## Case 2011-30

## Amendment to Case 2011-30.

AMMENDMENT to CASE 2011-30.

Figure 6: Details of amended proposal; corner closest to city-owned property is removed, increasing minimum setback to 3.5'.

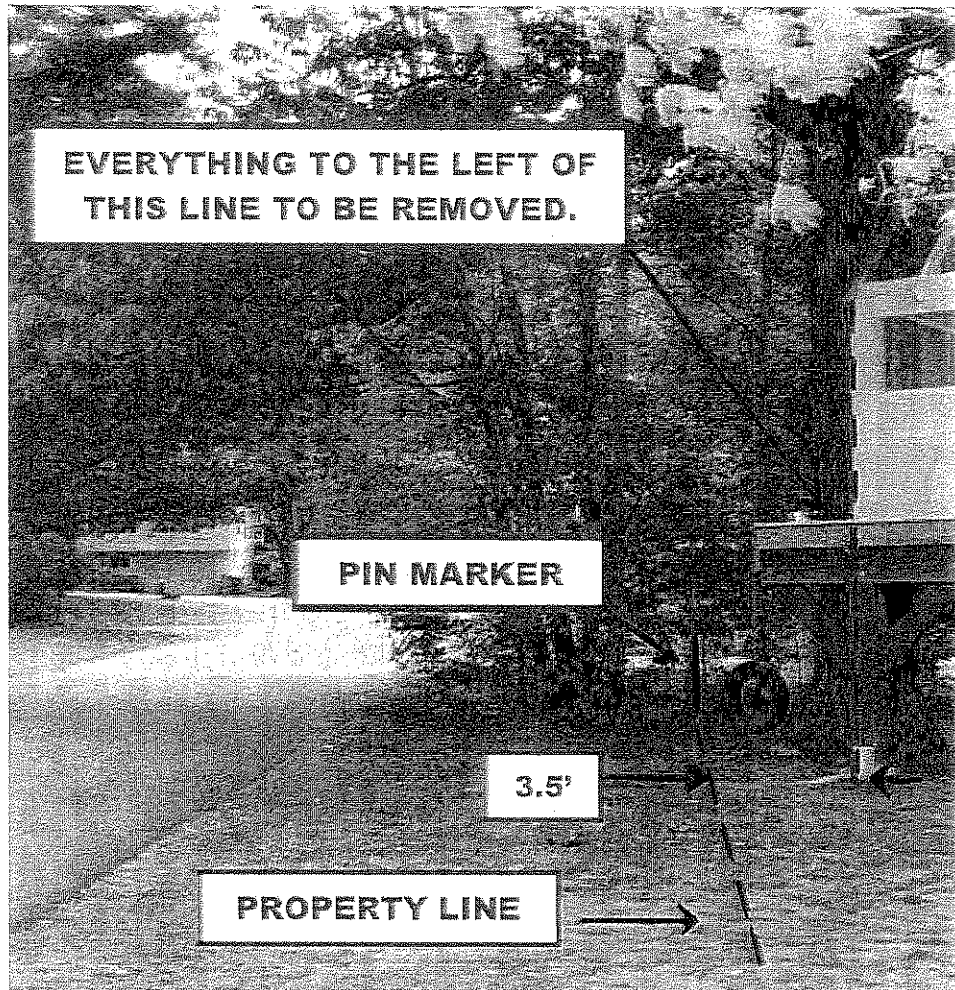
The applicant (B. Whalen) has chosen to amend the original proposal by removing the corner of the unit closest to the side lot line. This increases the minimum setback to the adjacent city-owned property to 3.5'. See Figure 6 below.

In addition to increasing the minimum setback to 3.5', removing this corner of the unit also places the entire unit "behind" the tree. In other words, the tree is now closer to the property line than any part of the unit.

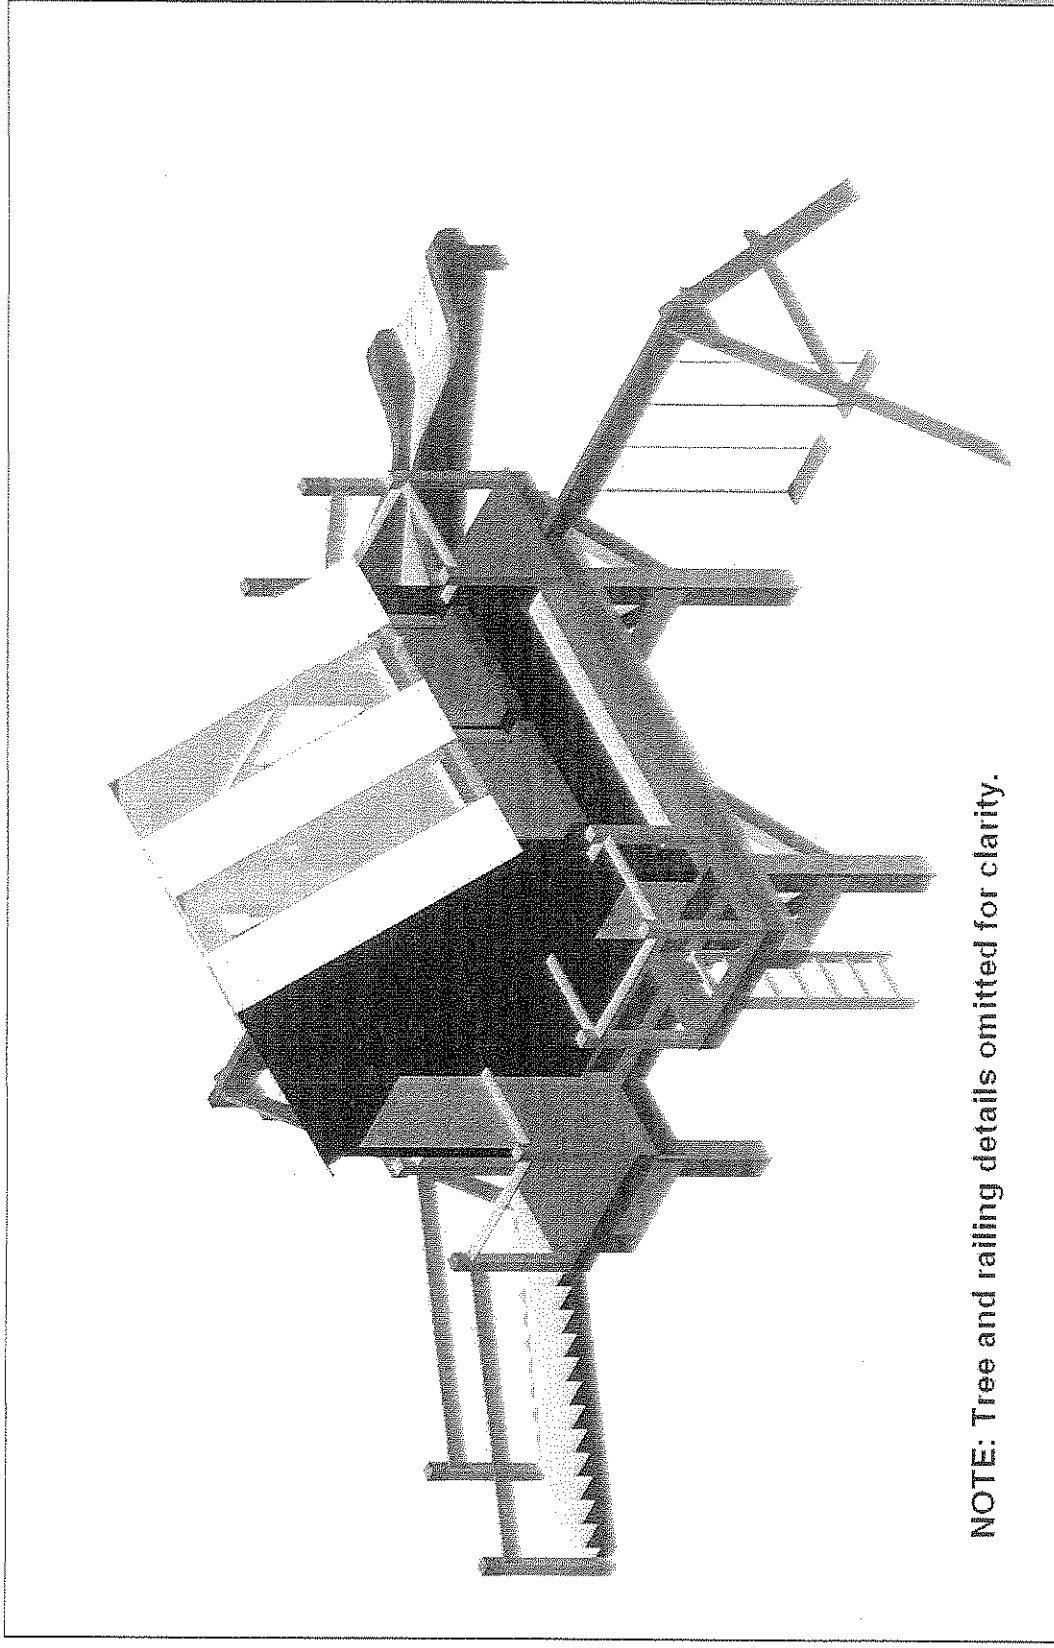
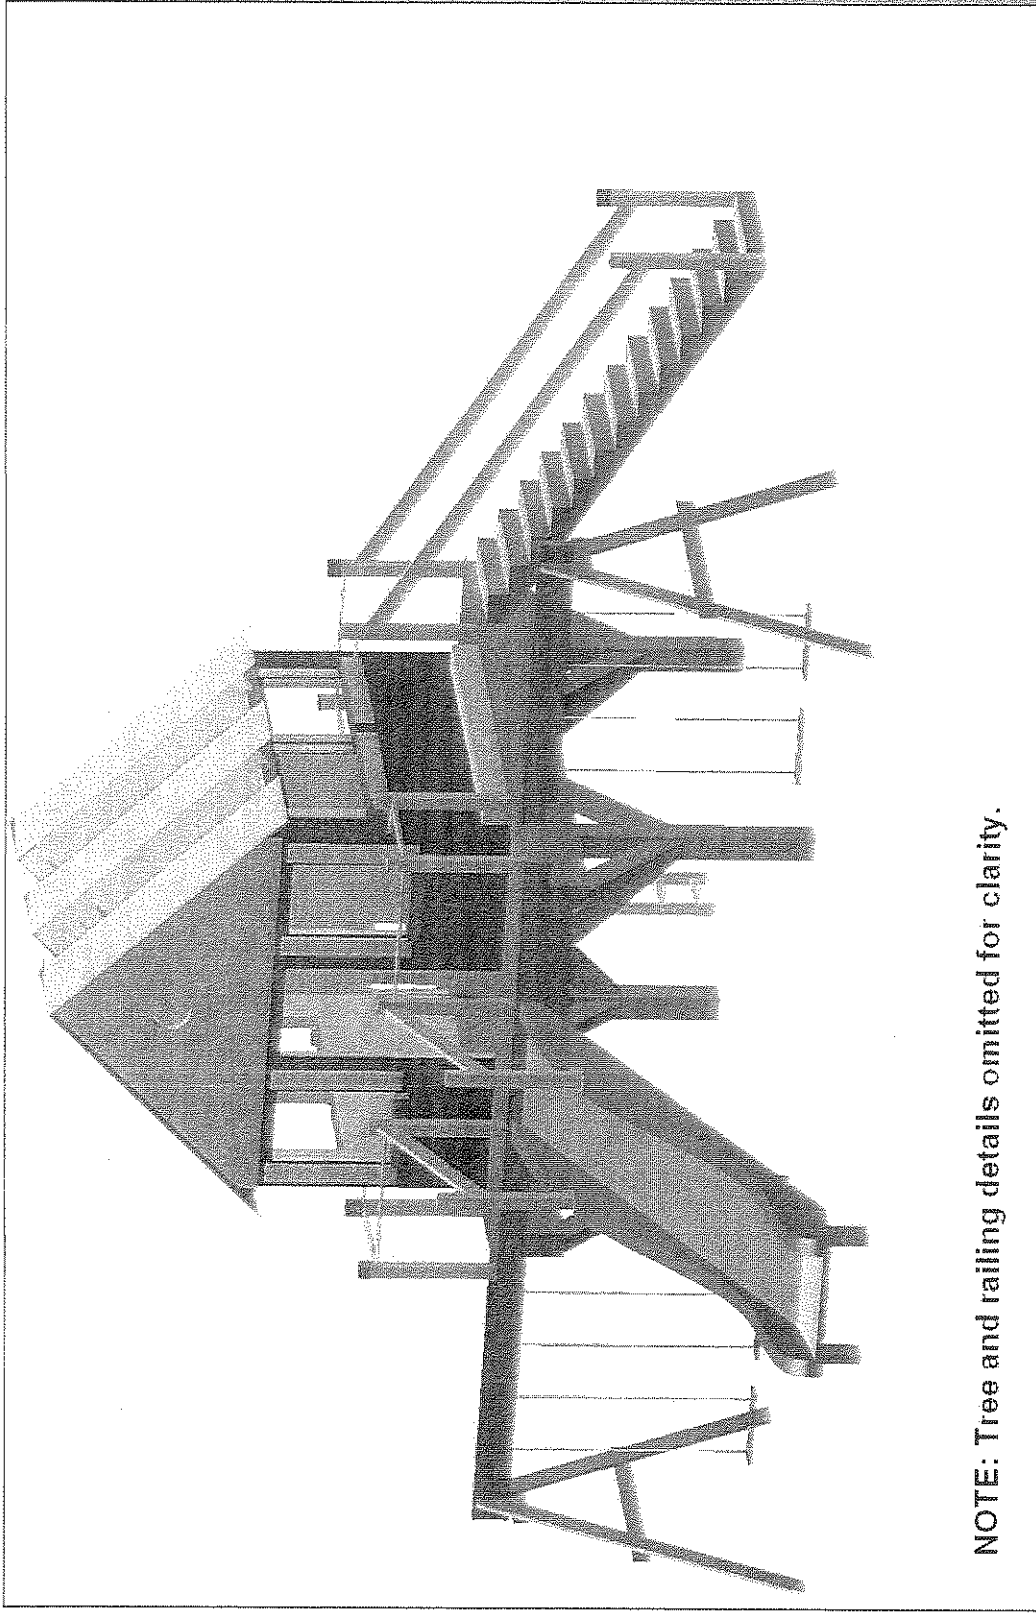
The following images are CAD representations of the *original* design intent for the tree house. They *DO NOT* show the modified design as outlined in Figure 6.

NOTE: The corner to be removed is the closest corner visible in this view.

Rear Access Via Ladder  
Attached to tree.

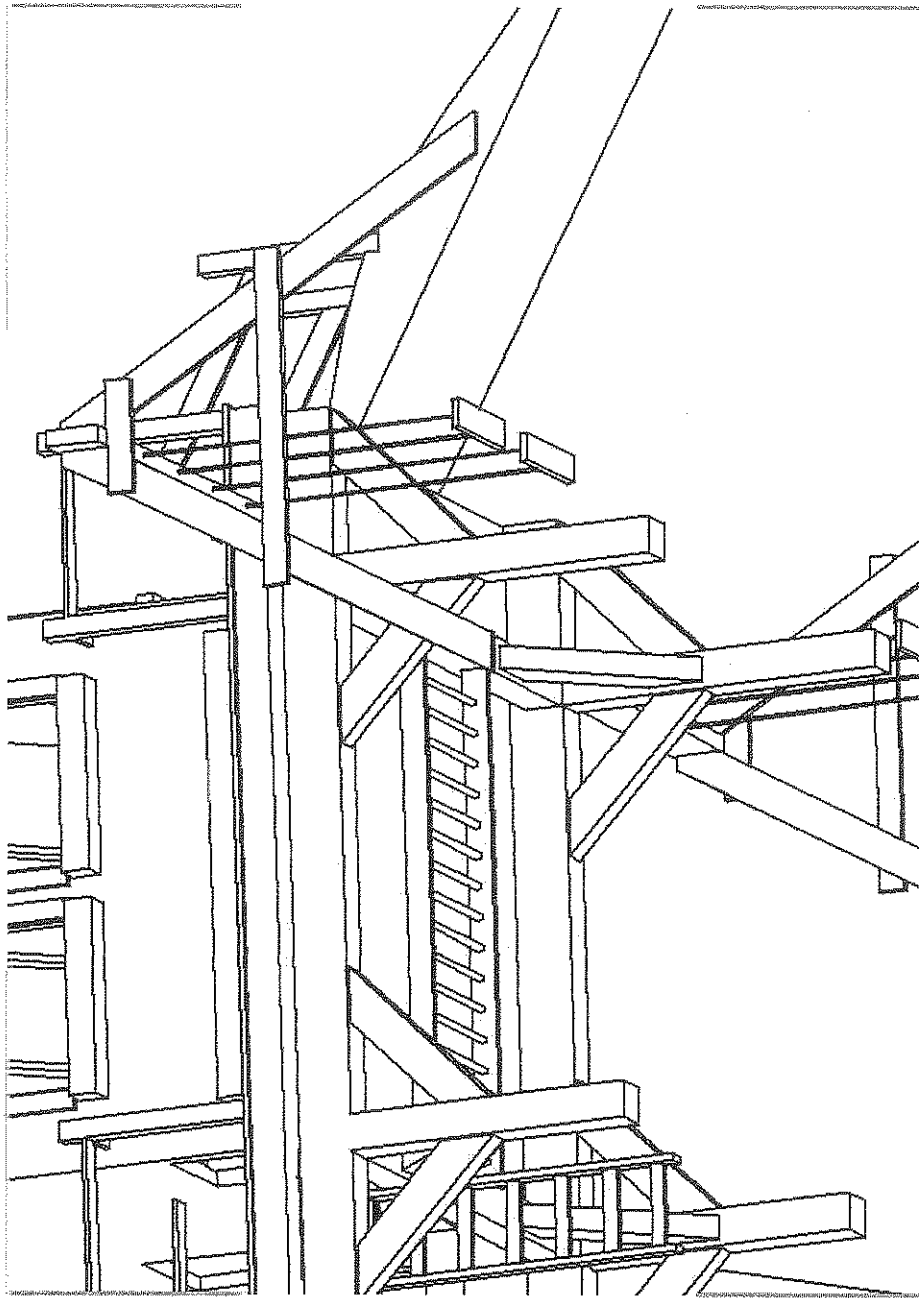
**NOTE:** Via the amended proposal, the ladder access detailed above will be entirely removed to increase minimum setback to 3.5'.
